# Access Compliance Report

## Public Rights-of-Way

### (Curb Ramps)

Intersection ID: 8847	Main Street: E_SUGAR_CREEK_RD	Cross Street: N_TRYON_ST	Location: SW
ADA ID: 83A3E29C01DD	Ramp Type: Perp	Initial Pass/Fail: Fail	Overall Compliance: No
Severity Score: 18.75			
Codes/Mitigation Info/Possible Solution		Field Measurements/Component Compliance

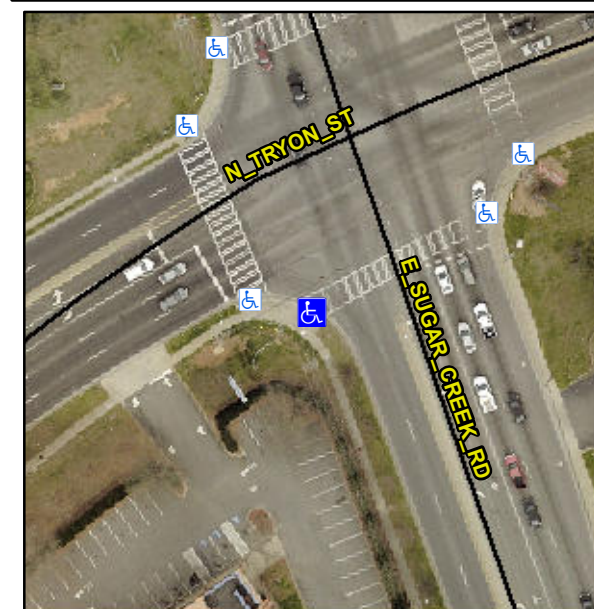
**Not Found, R304.5.1**

Compliance	Description	Data	Compliance	Description	Data
N/A	Ramp Length (in)	111.5	Yes	Ramp Slope (%)	5.8
No	Ramp Width (in)	34.5	Yes	Ramp XSlope (%)	4.7
N/A	Flare Type LT	N/A	N/A	Flare Type RT	N/A
N/A	Flare Slope LT (%)	N/A	N/A	Flare Slope RT (%)	N/A
N/A	Flare Traversable LT?	N/A	N/A	Flare Traversable RT?	N/A
N/A	Landing Length (in)	N/A	N/A	DWS Provided?	N/A
N/A	Landing Width (in)	N/A	N/A	DWS Contrast?	N/A
N/A	Landing Slope (%)	N/A	N/A	DWS Length (in)	N/A
N/A	Landing X Slope (%)	N/A	N/A	DWS Full Width?	N/A
N/A	Landing Curb? (Y/N)	N/A	N/A	DWS Offset (in)	N/A
N/A	Shared Landing?	N/A			
N/A	Gutter Ponding?	N/A	N/A	Gutter Slope (%)	N/A
N/A	Gutter Lip Ht (in)	N/A	N/A	Gutter X Slope (%)	N/A
N/A	Painted X Walk1?	Yes	N/A	Painted X Walk2?	N/A
	X Walk 1 Direction	To E		X Walk 2 Direction	N/A
N/A	X Walk 1 Width (in)	145.0	N/A	X Walk 2 Width (in)	N/A
	X Walk 1 Slope (%)	0.6		X Walk 2 Slope (%)	N/A
	X Walk 1 X Slope (%)	4.7		X Walk 2 X Slope (%)	N/A

**Remove & Replace Entire Ramp.**
